Application NMA/2025/0018

Under this Non Material Amendment application, Ameresco are proposing that a portion the works in the eastern field are carried out as site set up / commencement works ahead of the significant excavation processes involved in the BESS facility. This is proposed on the basis that the existing condition is concerned with controlling the processes involved in the excavation and formation of the bunds. We are satisfied that any significant soil movement is still controlled by the condition.

DRAWING TITLE
SITE WELFARE & CDM LAYOUT

DRAWING NUMBER
3001816-AME-BE-XX-DR-CV-0001

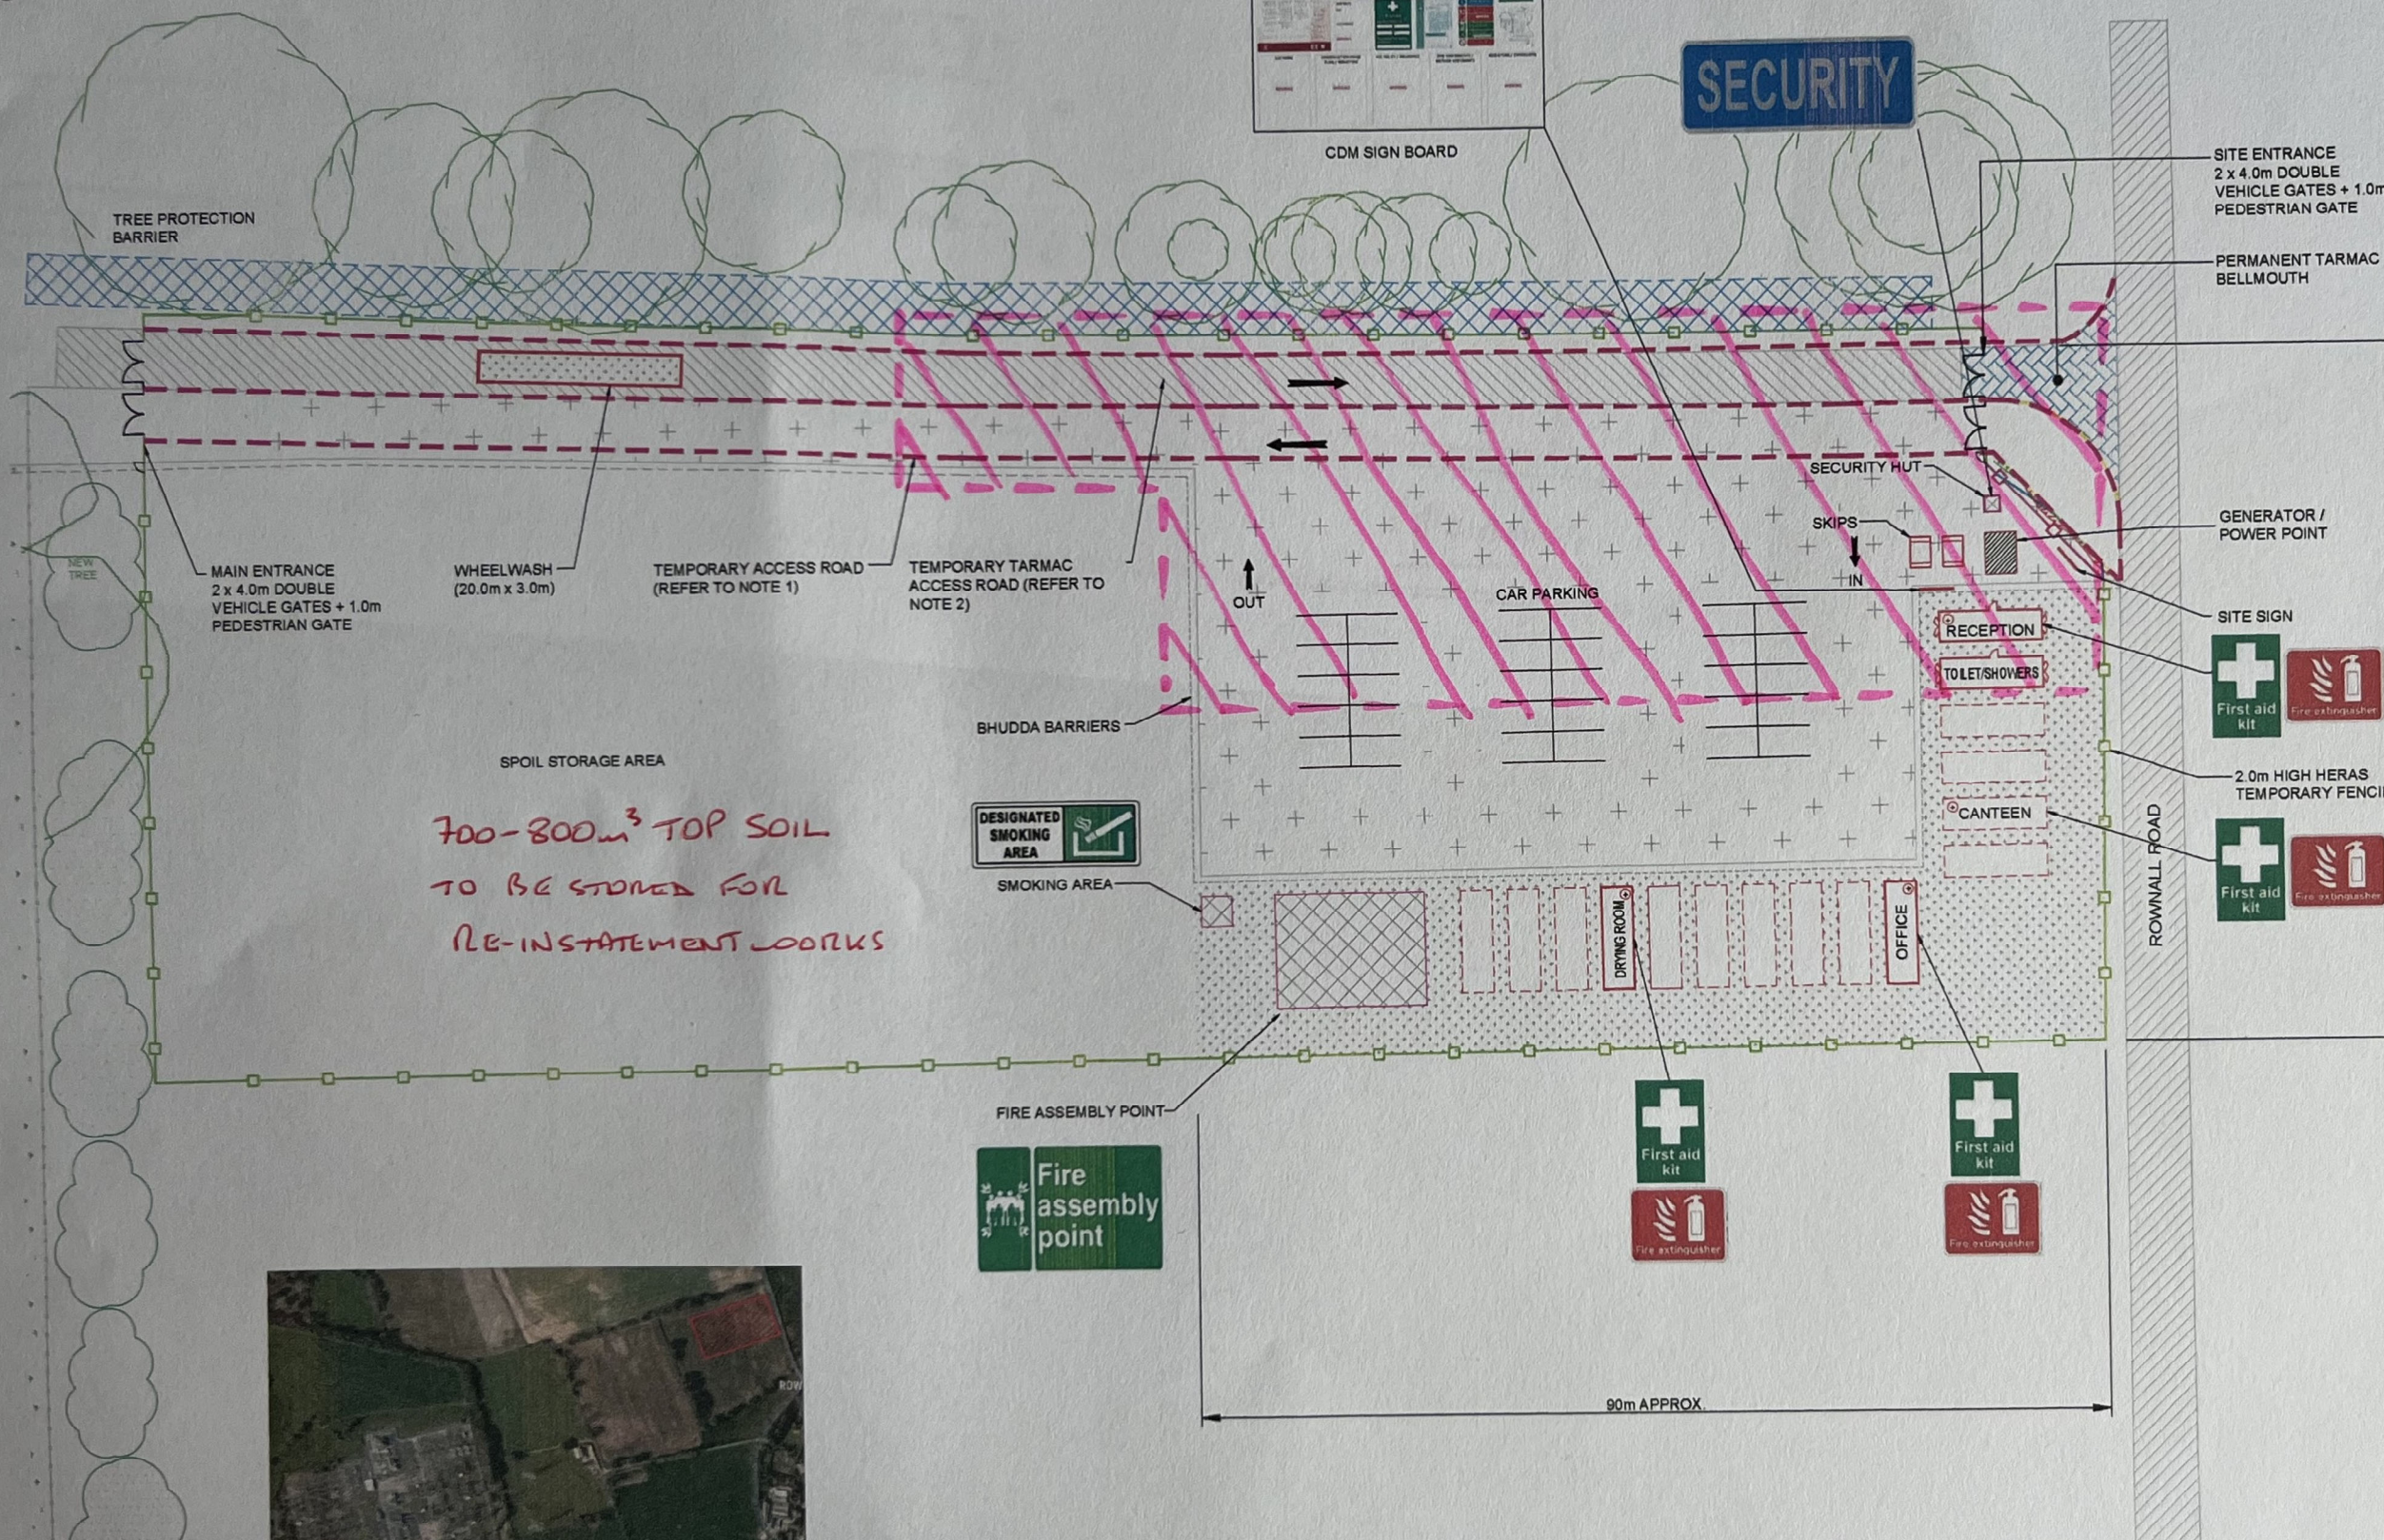
See mark up of approved construction compound / welfare area on following page.

In general terms the material from the access road area will be re-used in the compound. The small amount of excess topsoil not re-usable at this point is then to be temporarily stored in the spoil storage area ahead of re-use once the development works continue. The minor temporary storage in the spoil storage area will be sited adjacent to the compound area and no higher than 2 metres in height.

No soil will be removed from site. The formation of the compound involves the creation of a working / level bank, there is no bund creation.

700-800m³ TOP SOIL
TO BE STORED FOR
RE-INSTATEMENT WORKS
